Bulletin	Ampex 350 15 in/s NAB recording equalization
Date	15 Sept 05
Revision	1
Total pages	4

Figure 1. Disconnecting L401

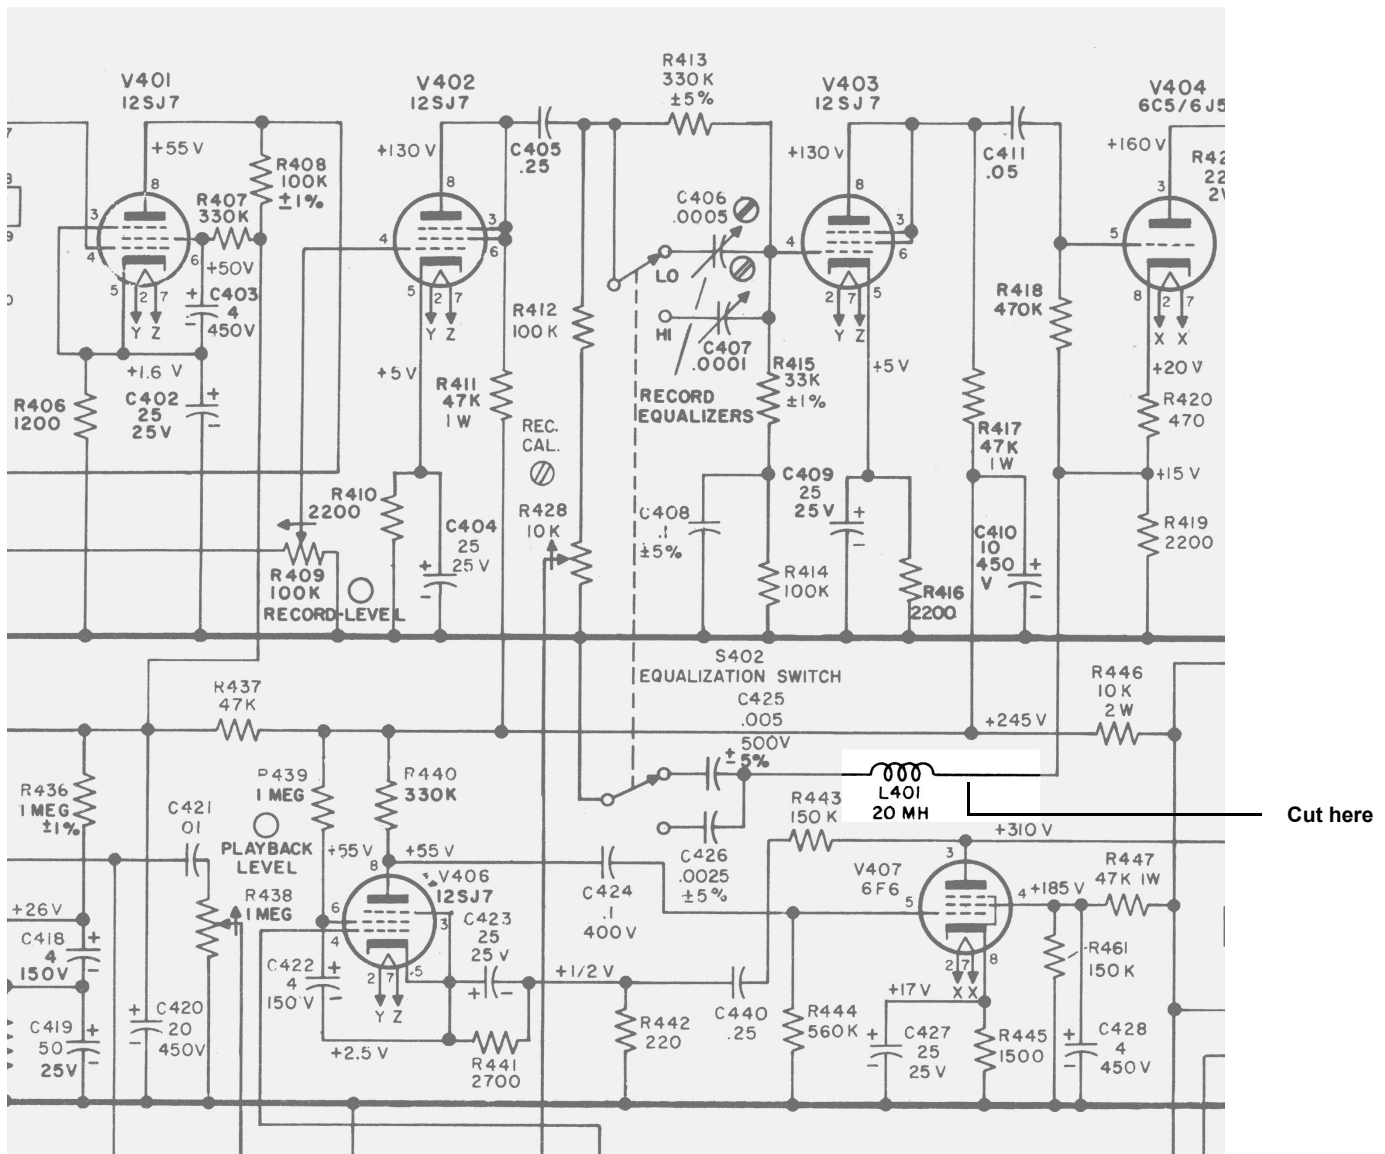
Part 1: Disconnect the record resonance circuit

The Ampex 350 was introduced in 1953. At that time, the predominant magnetic recording tape used in North America was 3M "Scotch" 111; this tape had a high-frequency droop in its record response that could not be corrected with a simple R-C equalizer. Consequently, inductor L401 (20 mH) was used along with capacitors C425 and C426 to form a resonant circuit to compensate for this droop. By the late 1950s however, magnetic recording tape had improved enough so that this circuit was no longer necessary—consequently, Ampex recorders designed after approximately 1960 did not use this circuit.

- 1 Disconnect ac power from the Ampex 350 power supply and disconnect the power supply cable from the electronics chassis.
- 2 Remove the bottom cover of the record/play electronics.
- 3 Locate L401; this is the 20 mH inductor mounted on the inside rear of the front panel between the record level potentiometer and the equalization switch. The location of L401 is obvious as there are no similar components located nearby.
- 4 Cut the green wire connecting one end of the L401 to V404 (6C5/6J5). After cutting the wire, cover the cut end with a short length of heat-shrink tubing and tuck the loose wire into a convenient location.

Figure 2. Record EQ switch modification

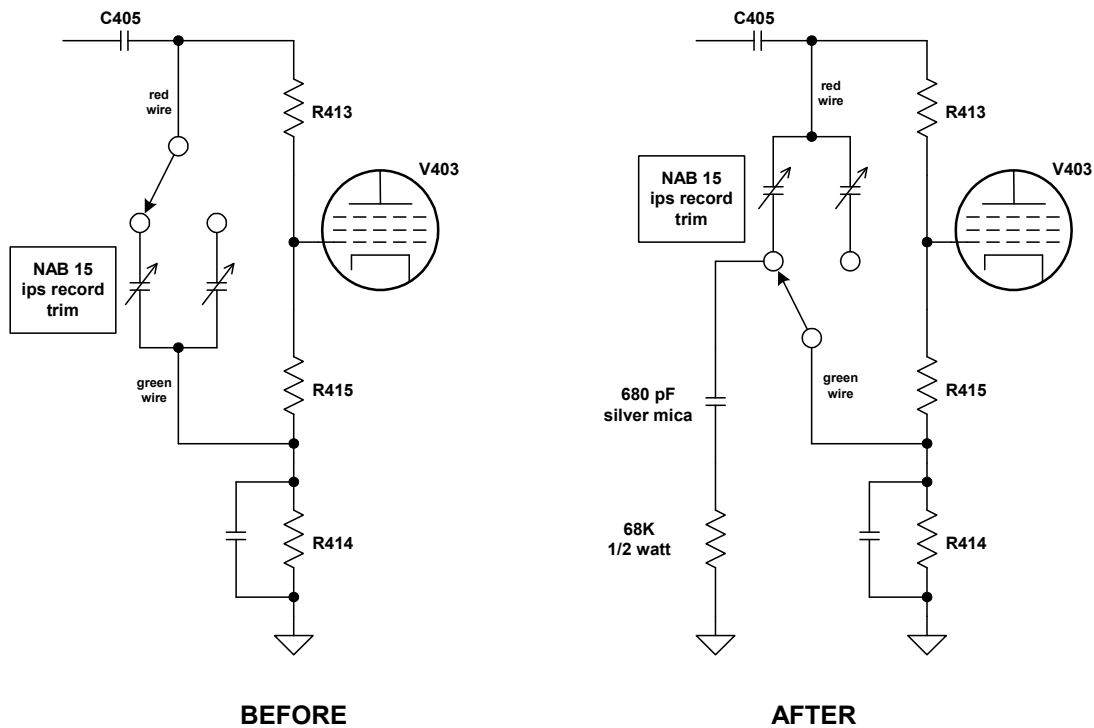
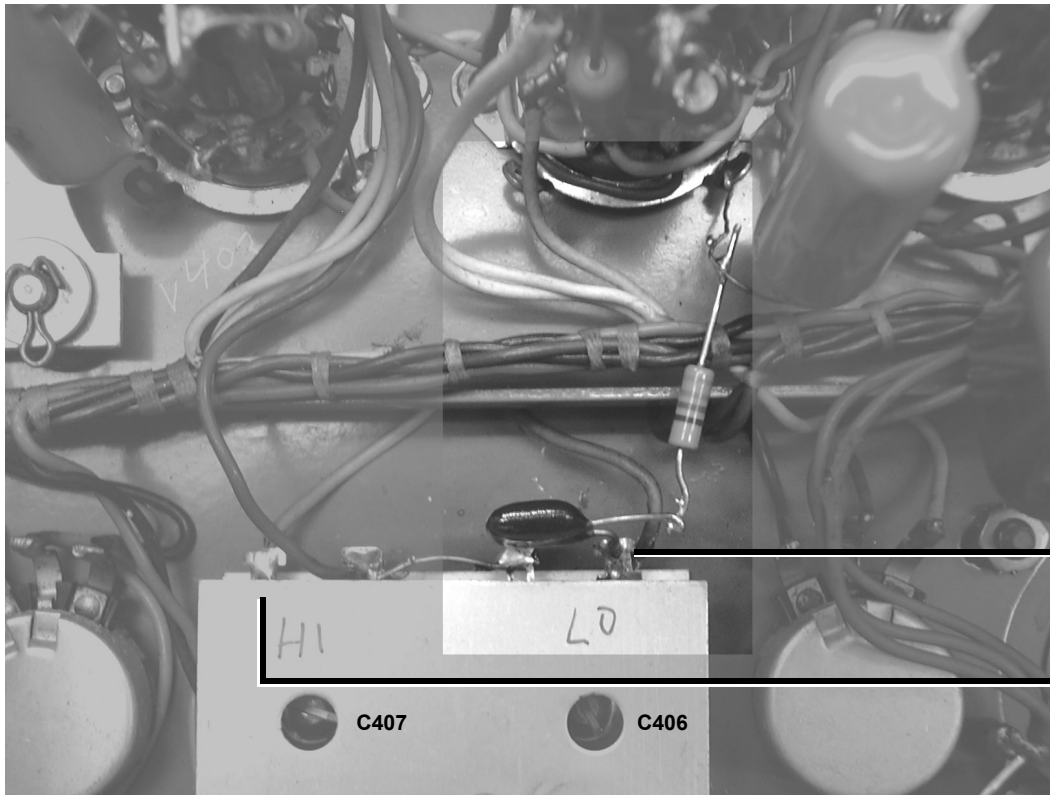
Part 2: Rewire the record switch

- 1 Locate the green wire where it joins the junction of the two trimmer capacitors (C406 and C407). Carefully unsolder the green wire at this location.
- 2 Locate the red wire where it joins the wiper terminal of the record equalization switch—this switch has several sections, so be sure to locate the correct wiper terminal. Carefully unsolder the red wire at the location.
- 3 Move the green wire to the wiper terminal of the record equalization switch. If the wire is not long enough, replace it with a longer length of green insulated wire (18 to 22-gauge stranded insulated wire is fine).
- 4 Move the red wire to the junction of the two trimmer capacitors.
